Memorandum to the City of Markham Committee of Adjustment May 1, 2024

File: A/013/24

Address: 57 George Street, Markham
Agent: Paar Design Inc. (Nikol Paar)
Hearing Date: Wednesday, April 3, 2024

Appendix "B" - Plans

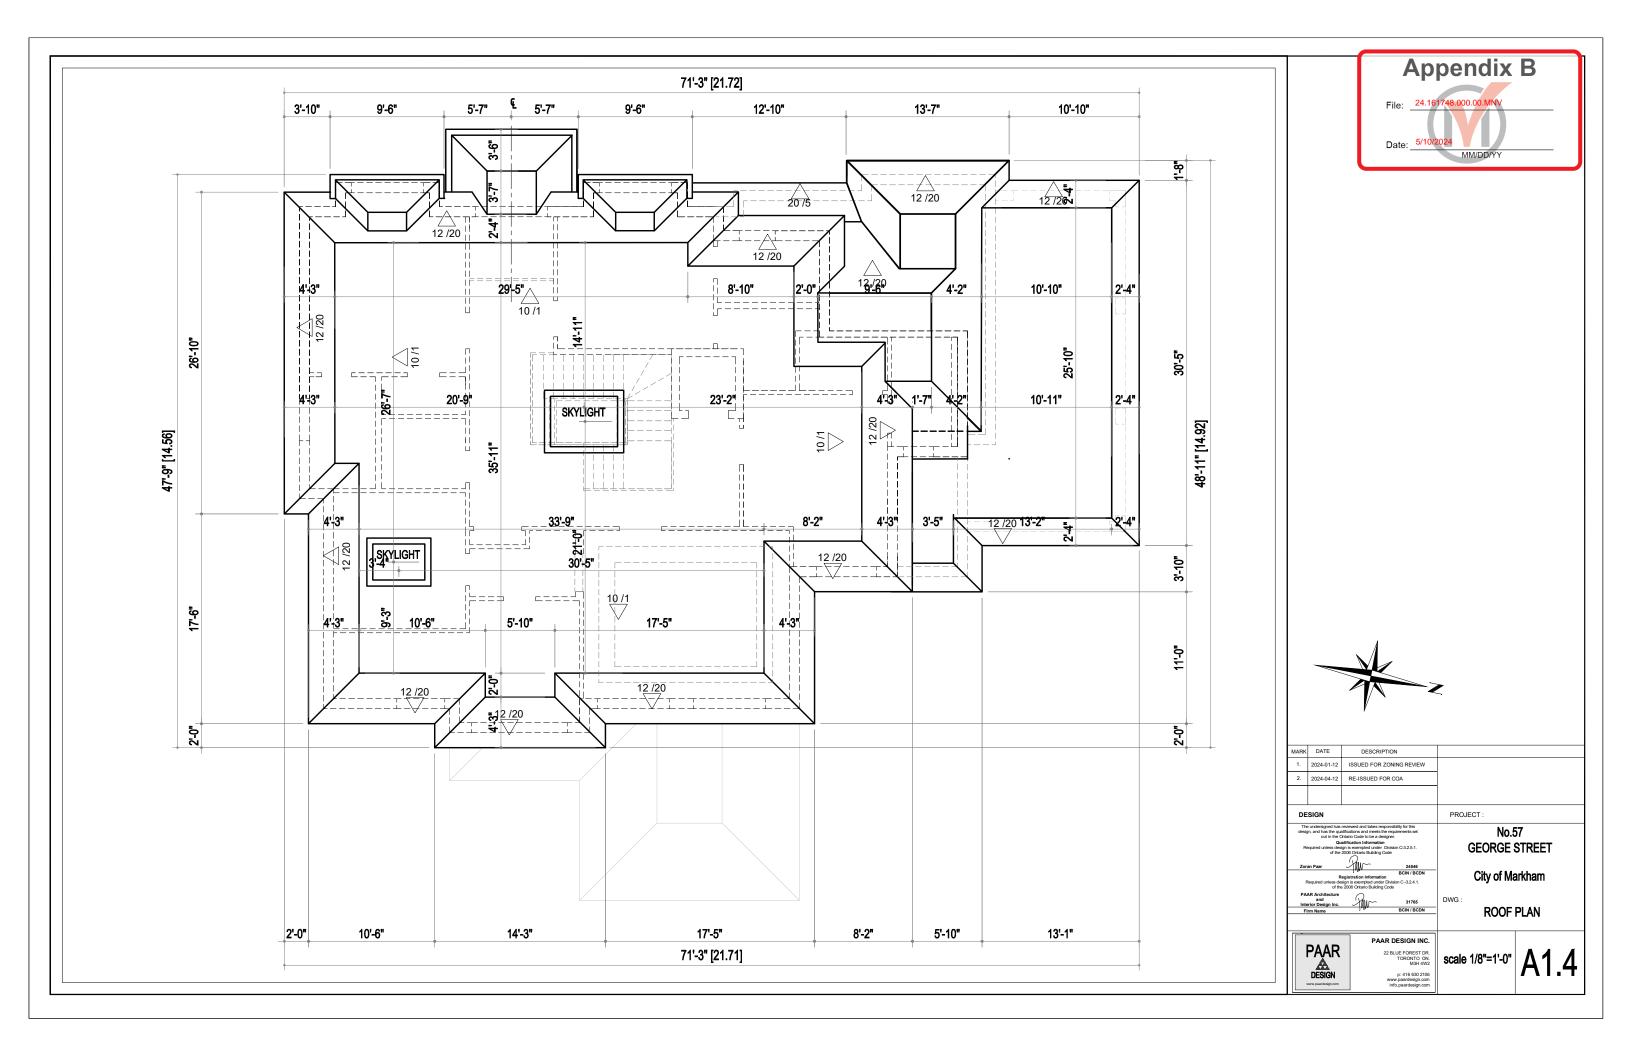
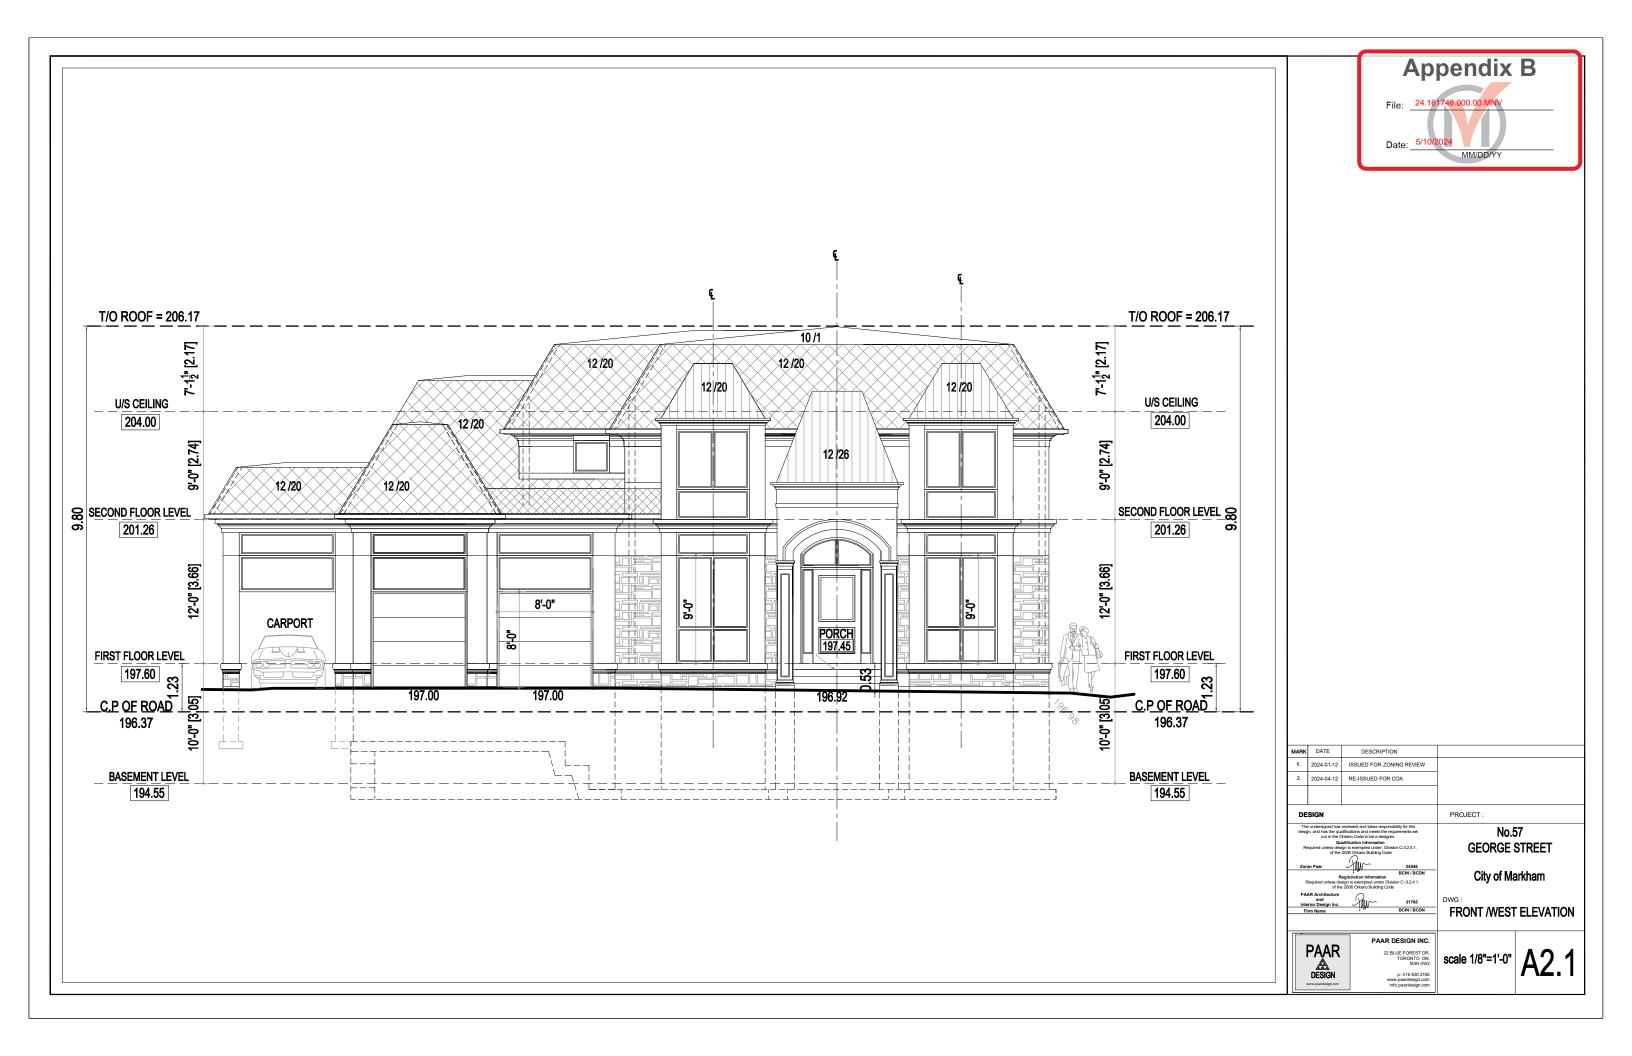
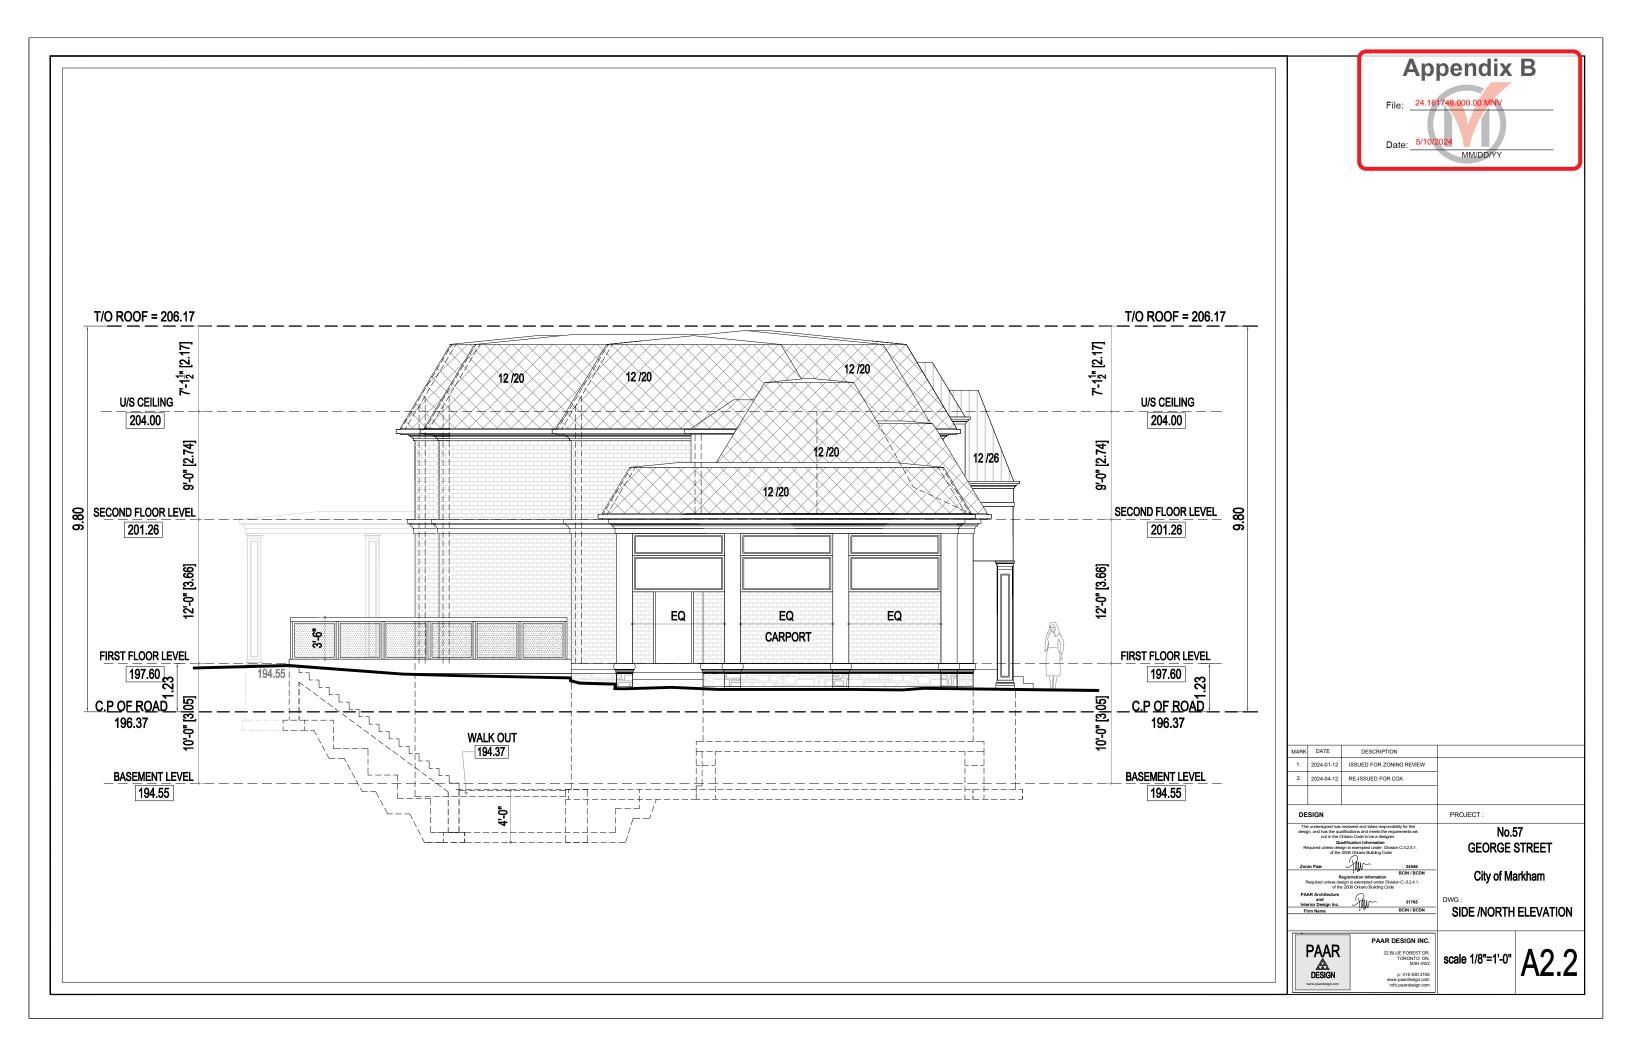
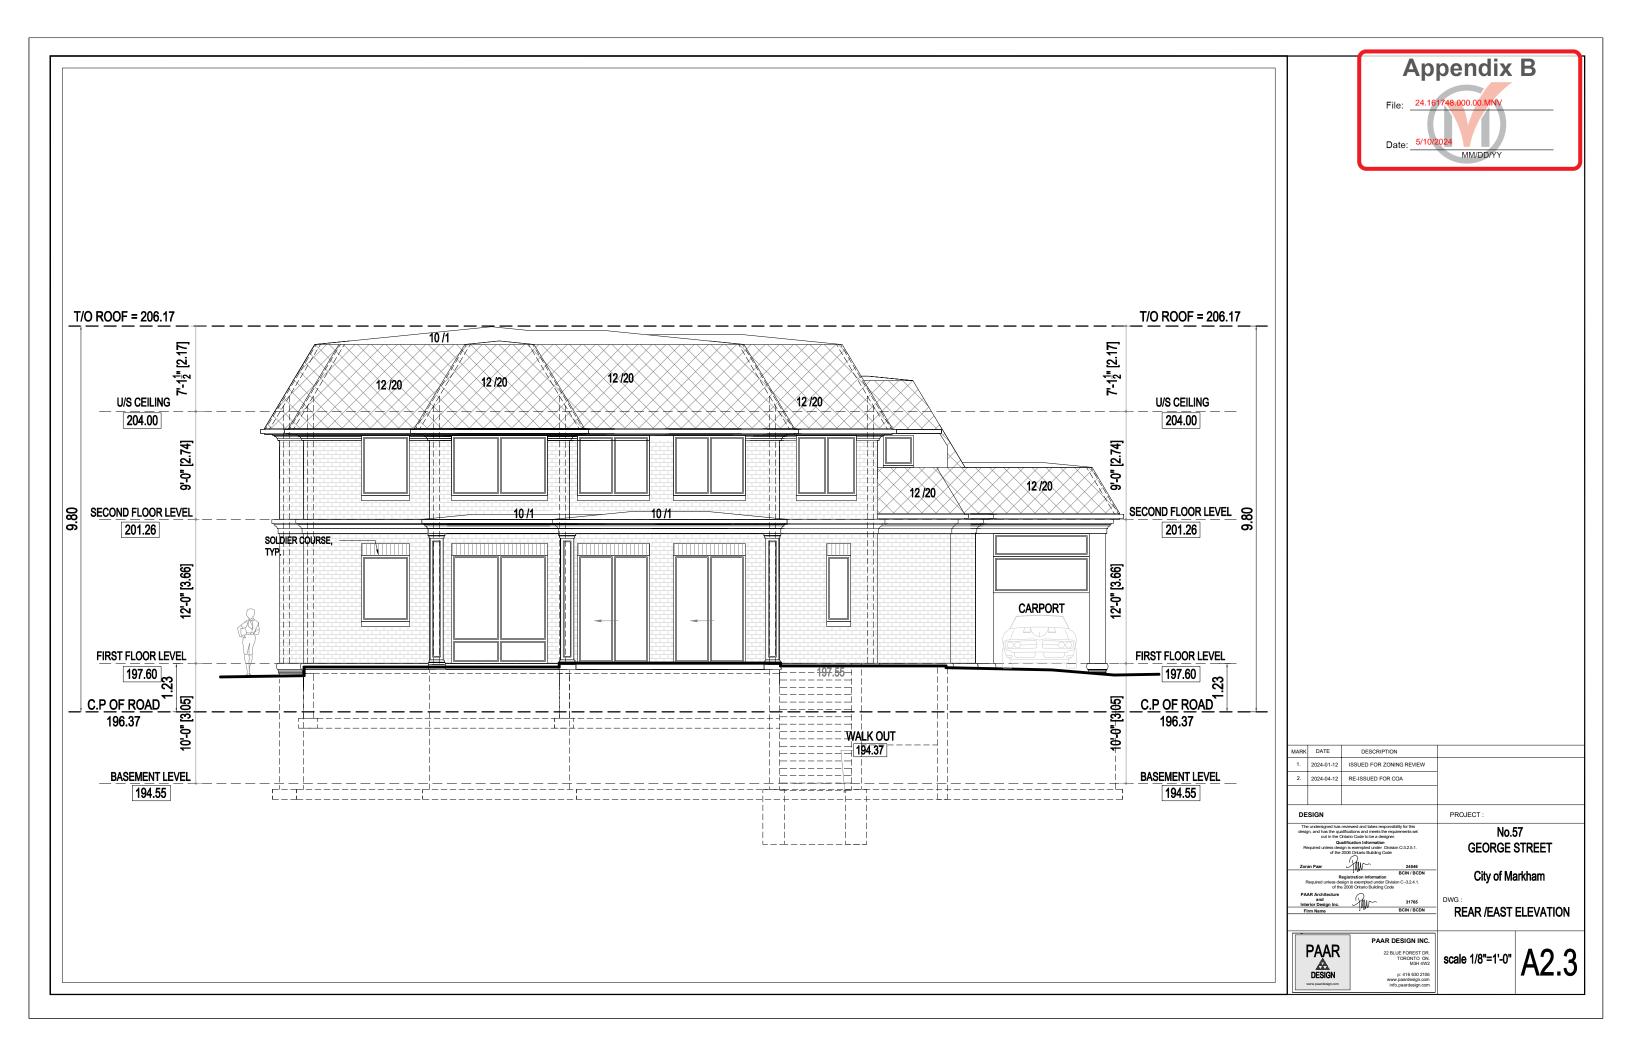
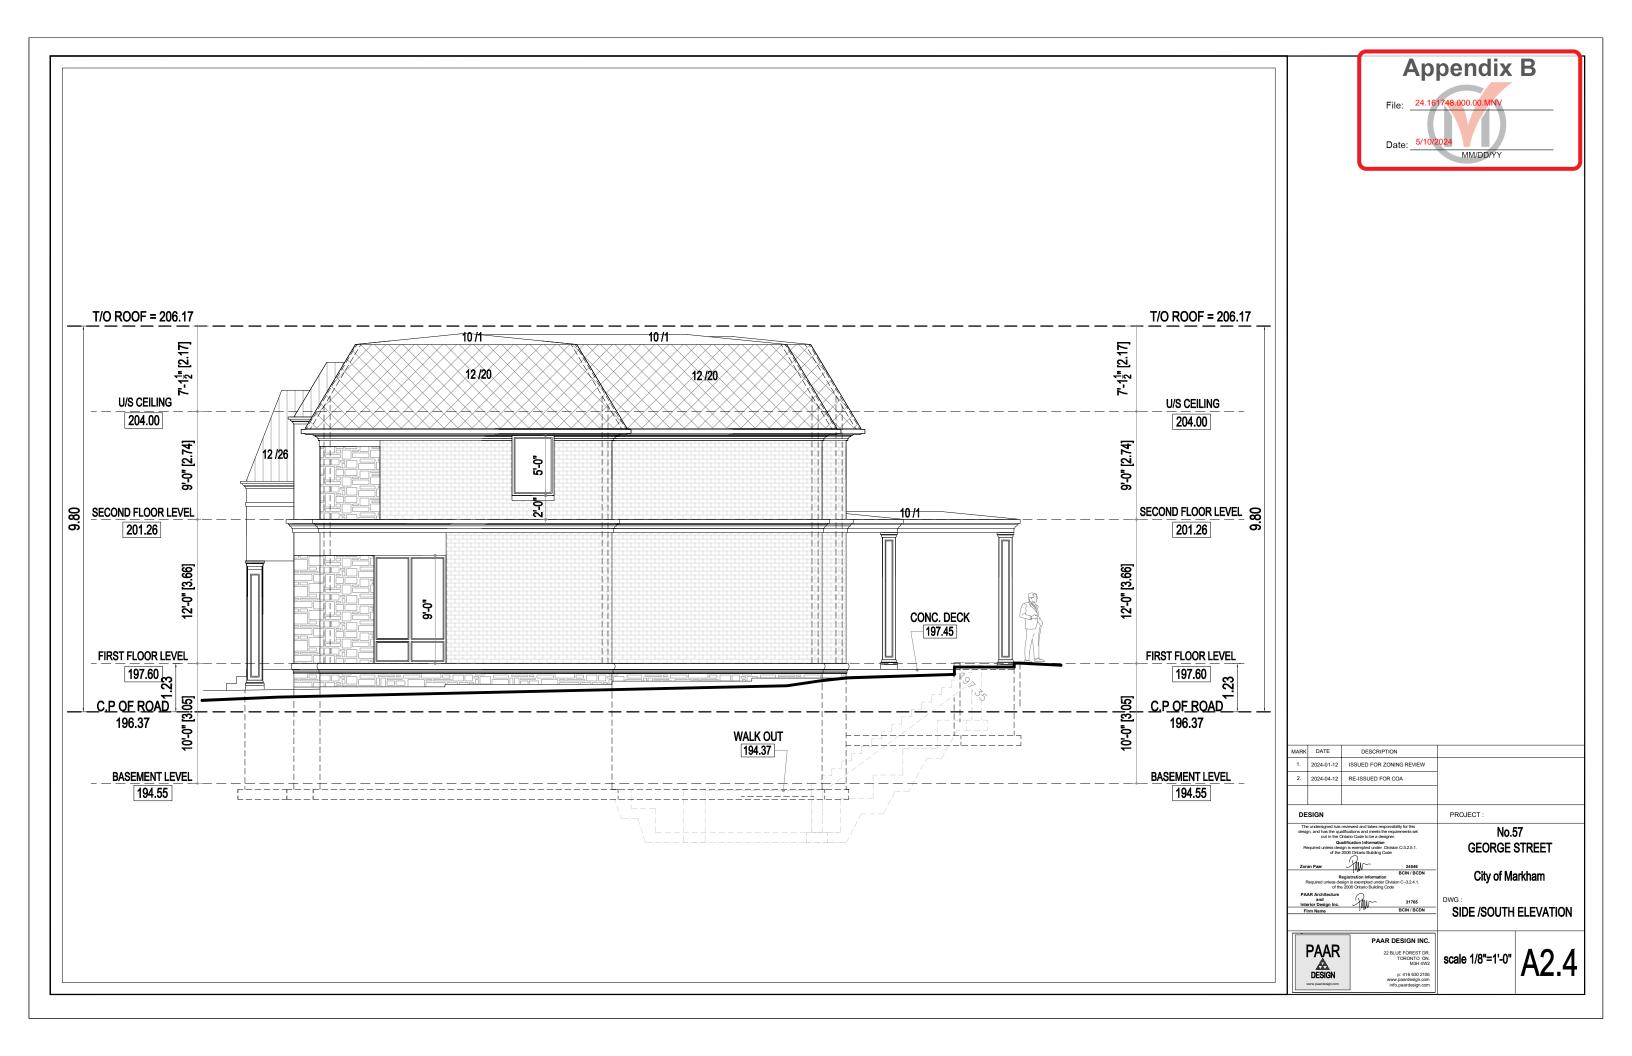
The Applicant is requesting relief to permit a floor area ratio of 48.78 percent, whereas the By-law permits a maximum floor area ratio of 45 percent. The variance will facilitate the construction of a two-storey detached dwelling with a floor area of 384.63 m² (4,140.11 ft²), whereas the By-law permits a dwelling with a maximum floor area of 354.74 m² (3,818.38 ft²). This represents an increase of approximately 29.89 m² (321.73 ft²).

Floor Area Ratio is a measure of the interior square footage of the dwelling as a percentage of the net lot area however; it is not a definitive measure of the mass of the dwelling. The building layout meets all other zoning provisions (such as setbacks and lot coverage) that establish the prescribed building envelope, which ensures the proposed dwelling will be in keeping with the intended scale of residential infill developments for the neighbourhood.

The intent of maximum floor area provision in the By-law is to ensure that the overall size of the proposed dwelling will be in keeping with the intended scale of residential infill developments in the neighbourhood. Although the gross floor area is aligning with other recent infill development projects within the neighbourhood, it is noted that the floor area ratio reduction subject to this application has predominantly been a result of converting a portion of the garage to a partially enclosed carport instead of a three car garage. The overall scale of the proposed dwelling has remained relatively unchanged, aside from the carport and reduced roof pitch above, which remains a concern to staff.

The Applicant is requesting relief to permit a maximum building depth of 20.10 metres (65.94 feet), whereas a maximum building depth of 16.80 metres (55.12 feet) is permitted. This represents an increase of approximately 3.60 metres (11.81 feet).

The variance includes a front covered porch and rear covered concrete deck which adds approximately 4.25 metres (14 feet) to the overall depth of the building. The main component of the building, excluding the front covered porch and rear covered deck has a depth of approximately 15.21 metres (50 feet), which complies with the By-law requirements. The requested building depth variance is entirely attributable to the proposed front covered porch and the rear covered concrete deck. The proposed dwelling consists of a south side yard setback of 1.83 metres (6 feet), and a north yard setback of 4.83 metres (15.85 feet) and will not result in any impact to abutting properties.

Staff are of the opinion that the variance request is minor in nature and therefore have no concerns with the building depth of the proposed dwelling.
